# RICHMOND 300 ZONING CODE REFRESH

Review of Changes Made For November Draft  
December 2025 ZAC Meeting

# SUMMARY OF NOVEMBER DRAFT CHANGES

# DRAFT 1

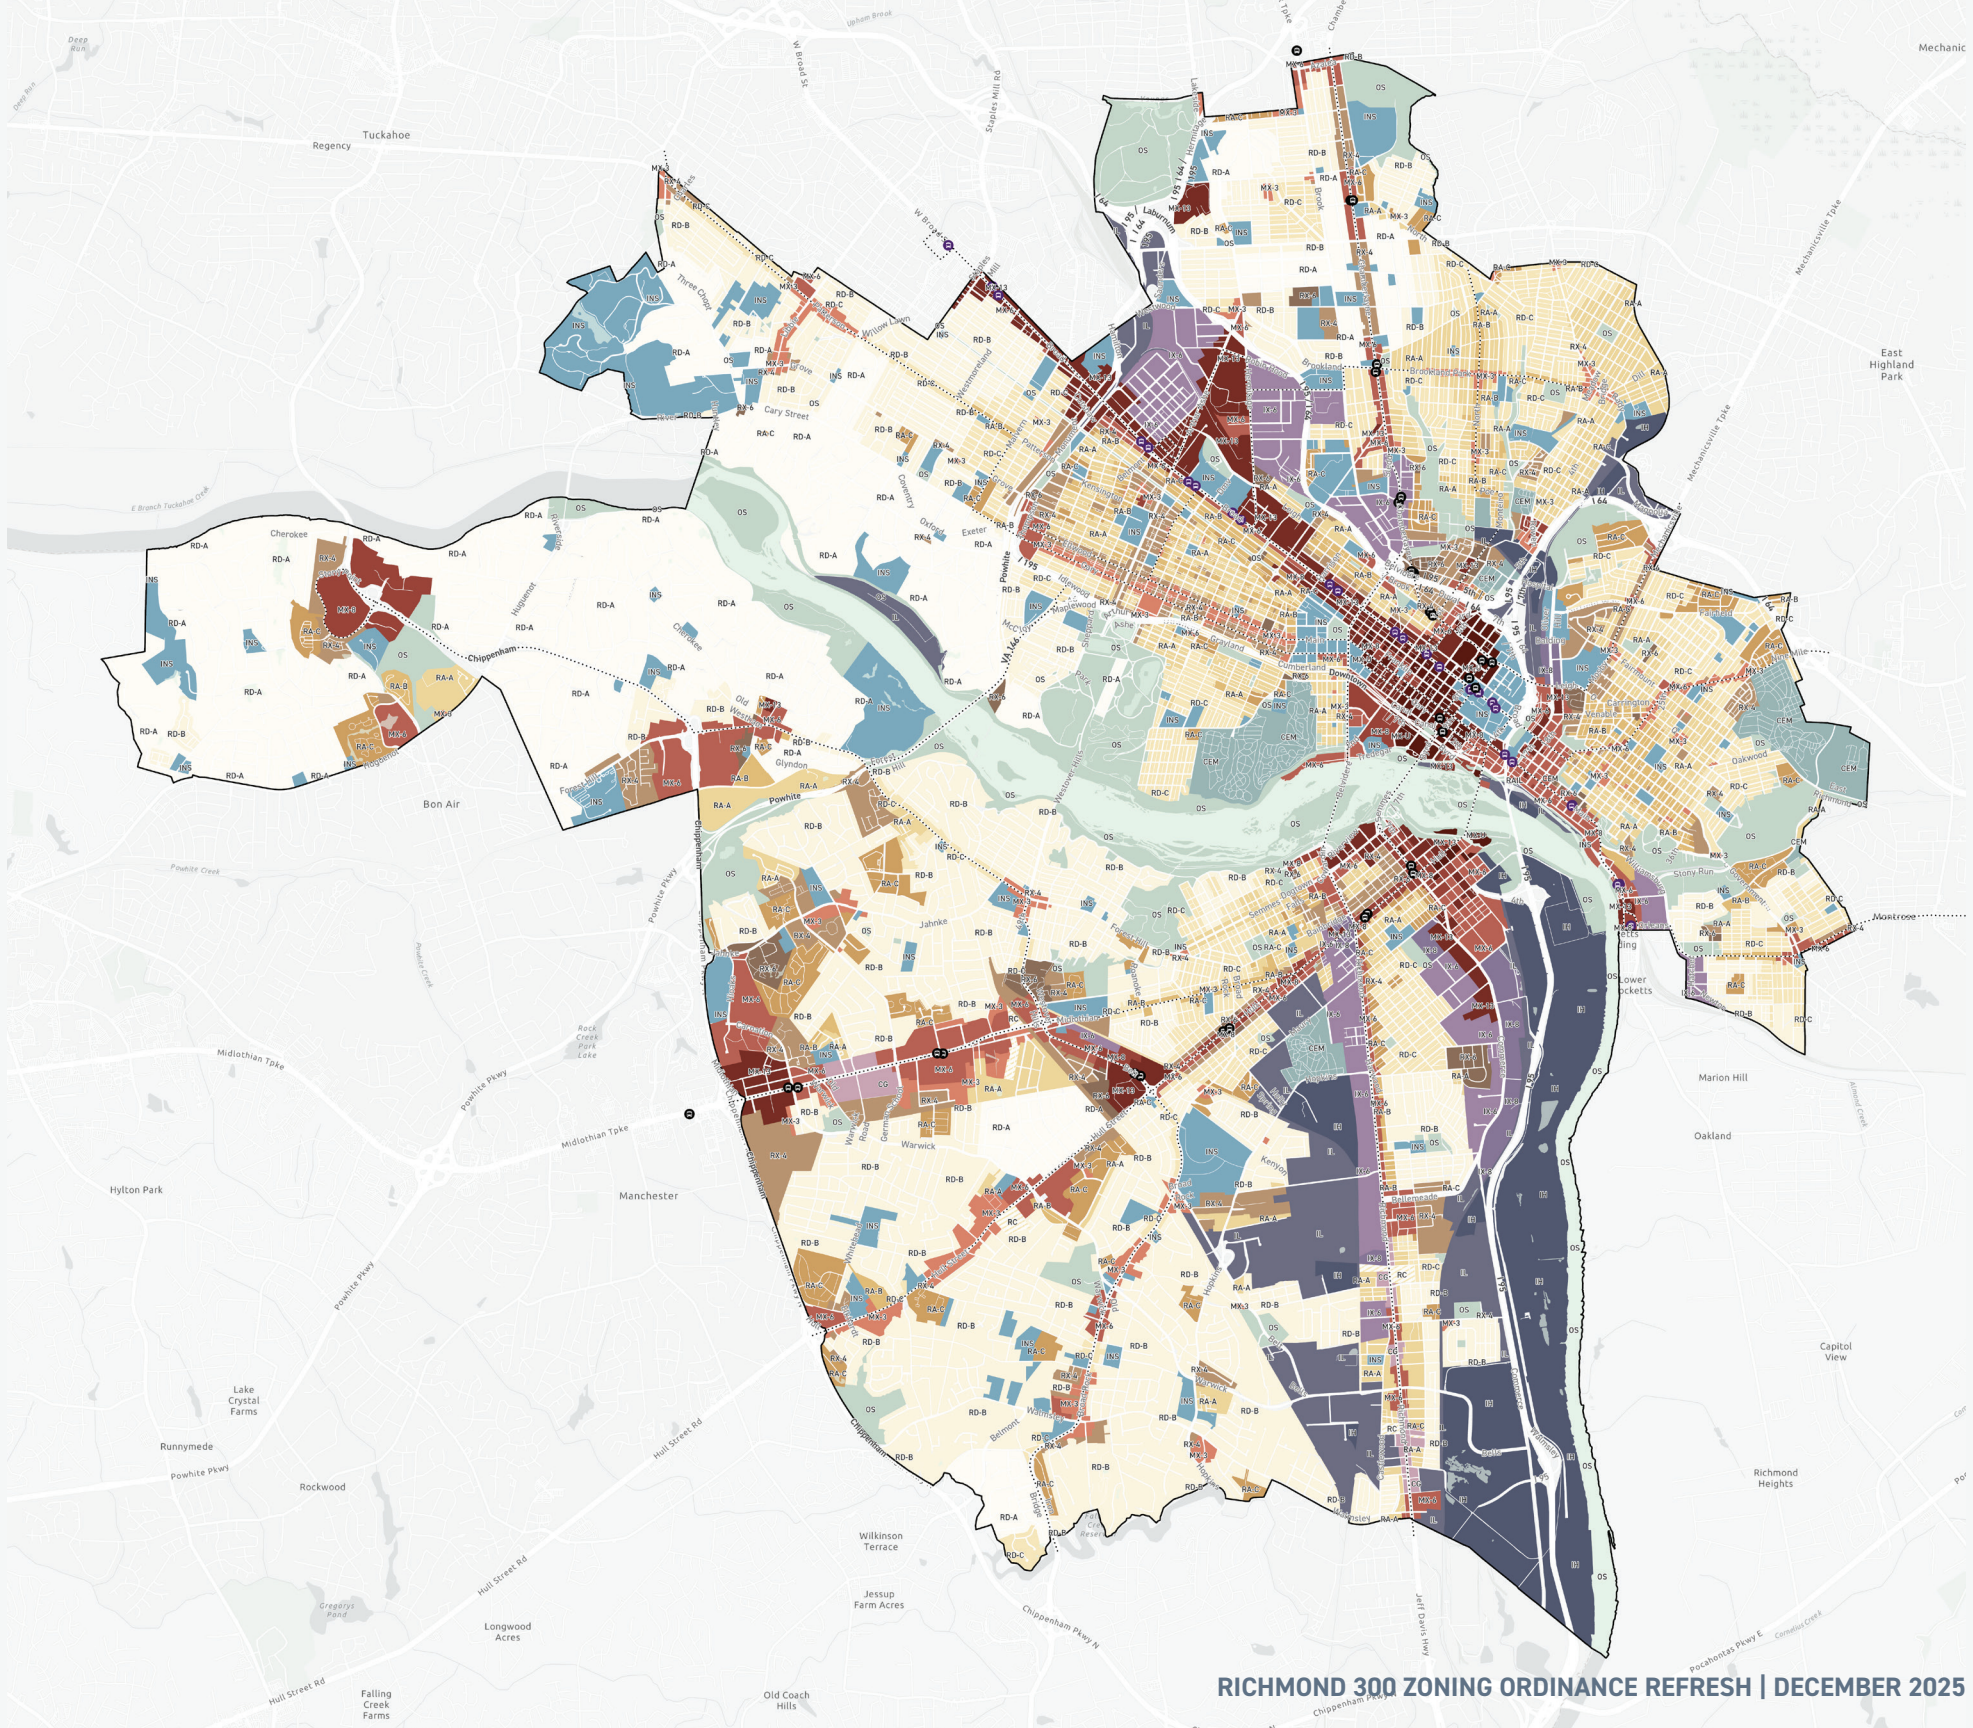
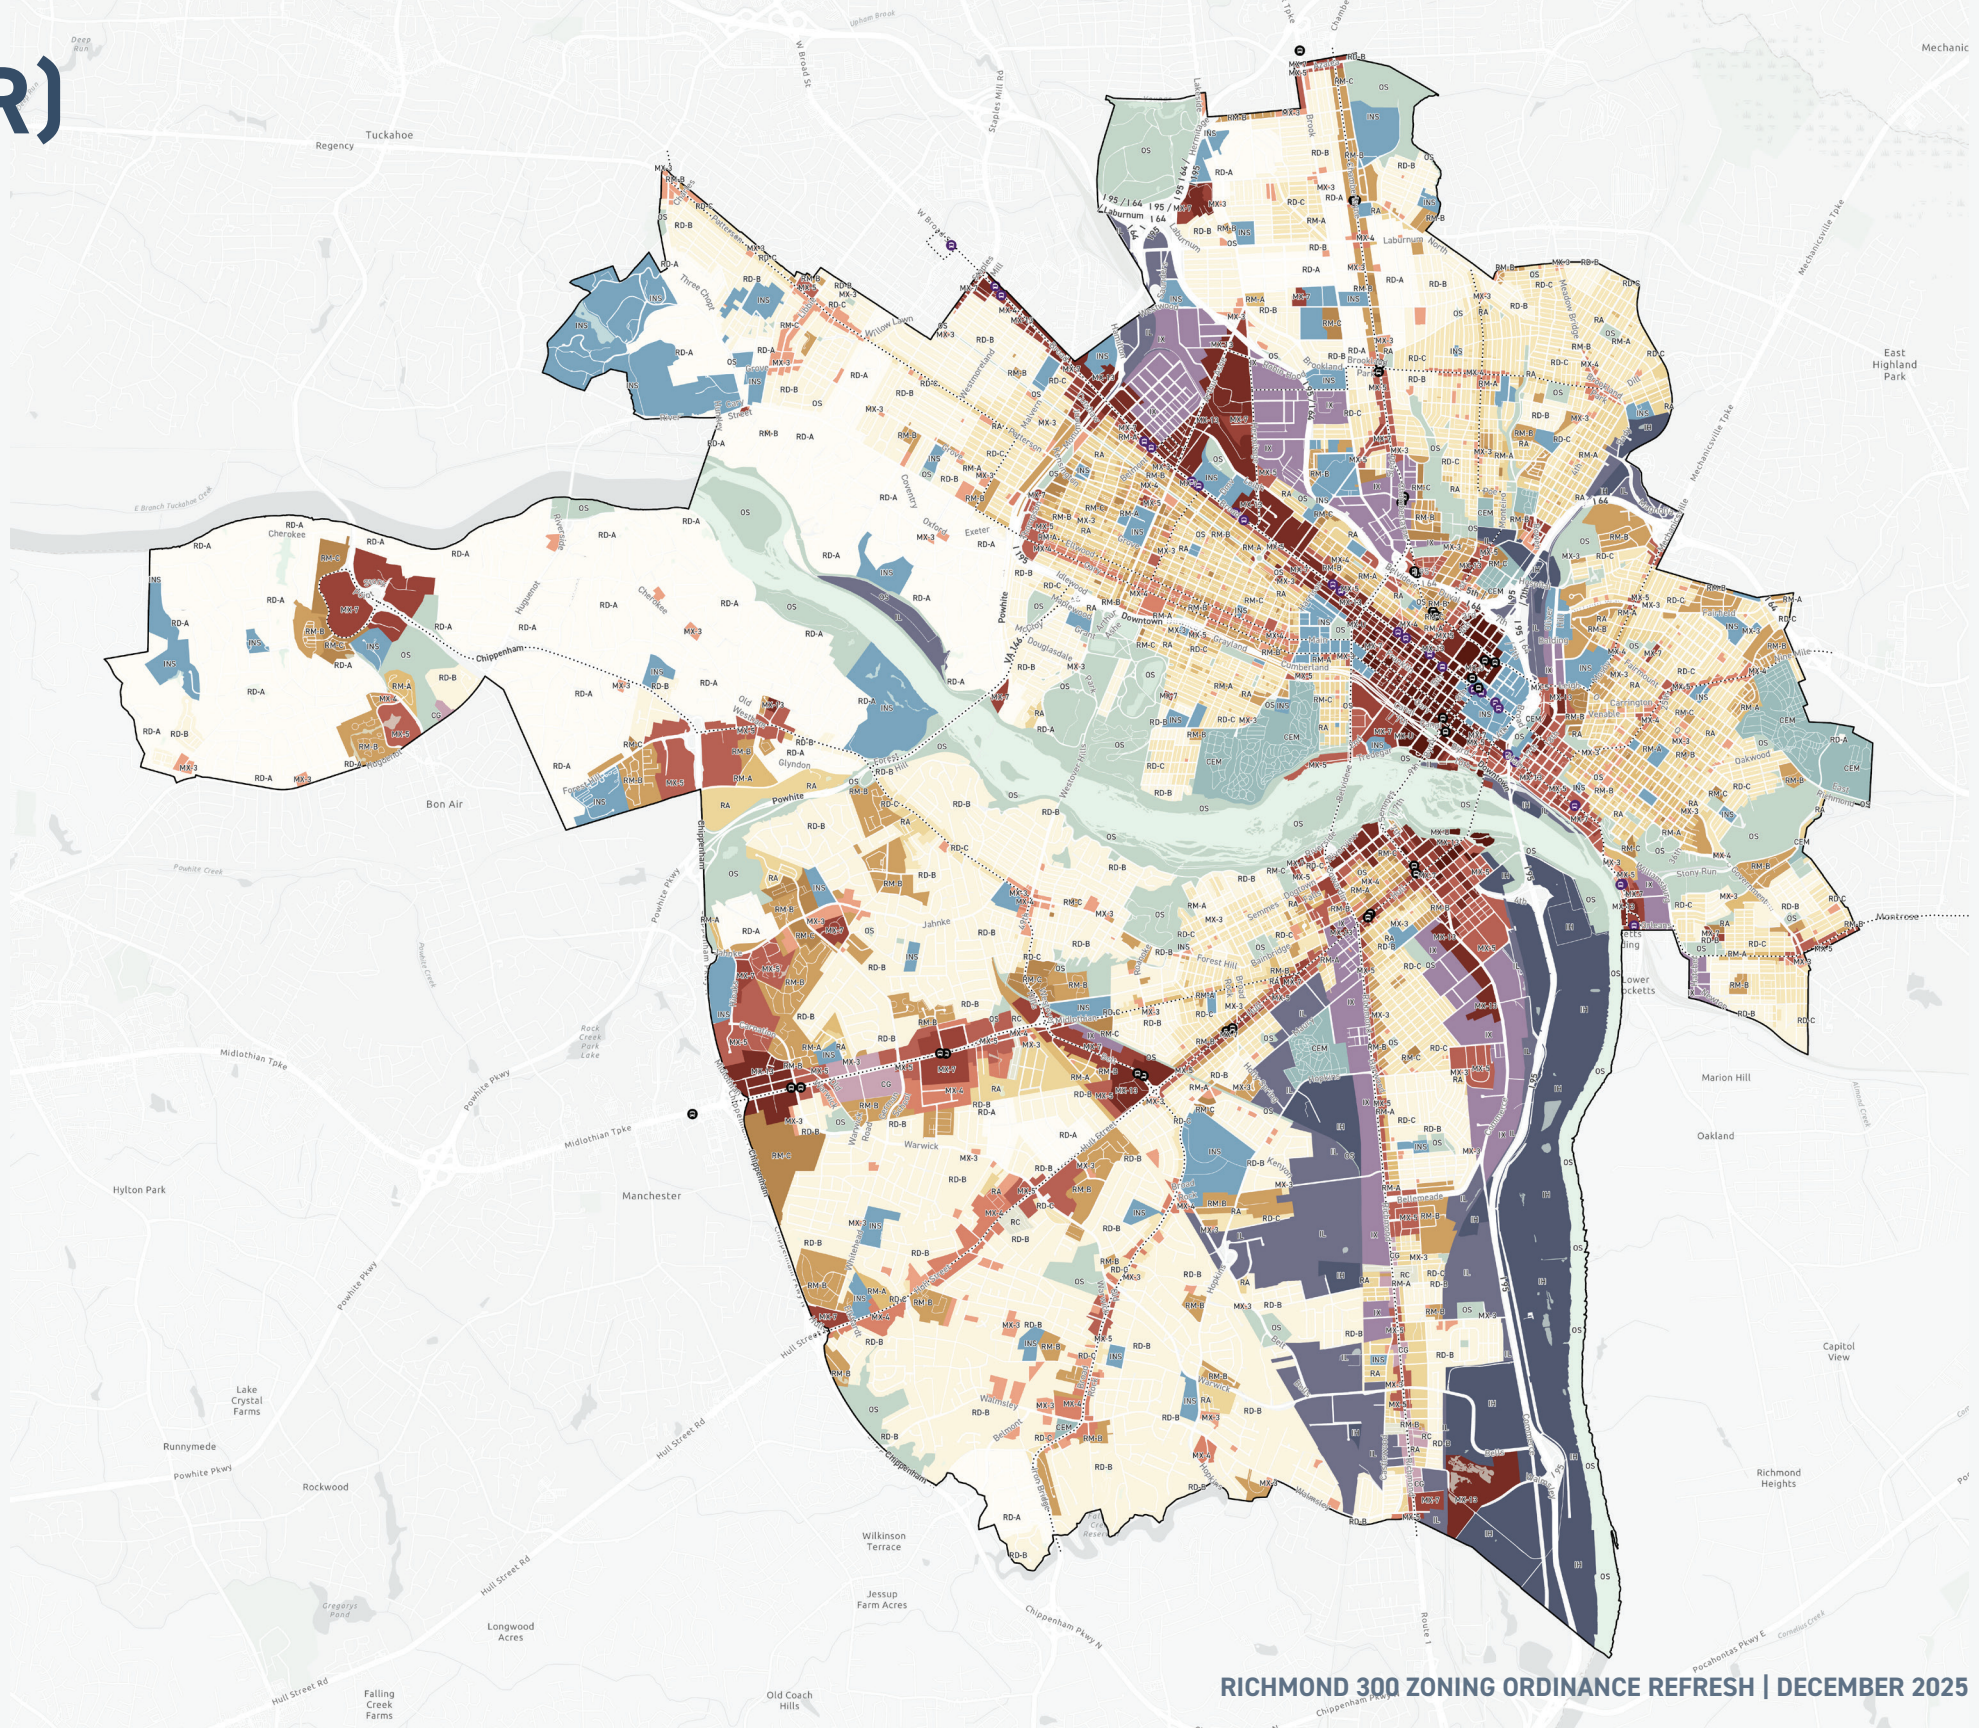
Some zoning district names changed to help clarify their intent, and in some cases, the frequency that a district appears on the map also changed.

Major changes included the introduction of RM (replacing RA-B, RA-C and RX-4), adjustment to MX maximum heights and consolidation of IX.

# RESIDENTIAL UNITS PER LOT & MINIMUM LOT WIDTH

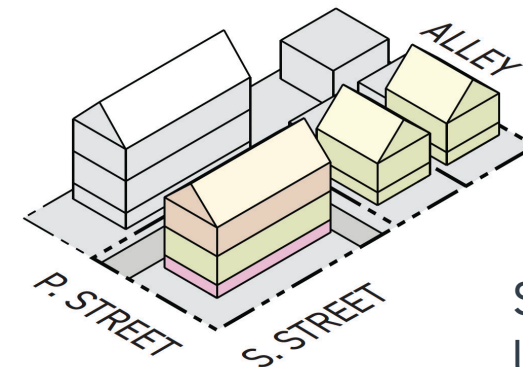
- + In RD- districts, some were in favor of allowing up to 2 units & 1 ADU on a lot, but others didn't want that type of change in their neighborhood
- + Some were concerned that the 25' min lot width in RD-C would incentive lot splits
- + Other worried that the proposed standards could incentivize the demolition of existing houses

- + New standards established to incentivize preservation of existing houses
- + The RD-C 25' lot width min has been kept, but the district has been mapped more sparingly, resulting in some areas becoming RD-B (50' lot width min)
- + Corner lots can only be subdivided along primary streets

Side street subdivisions of corner lots are no longer proposed
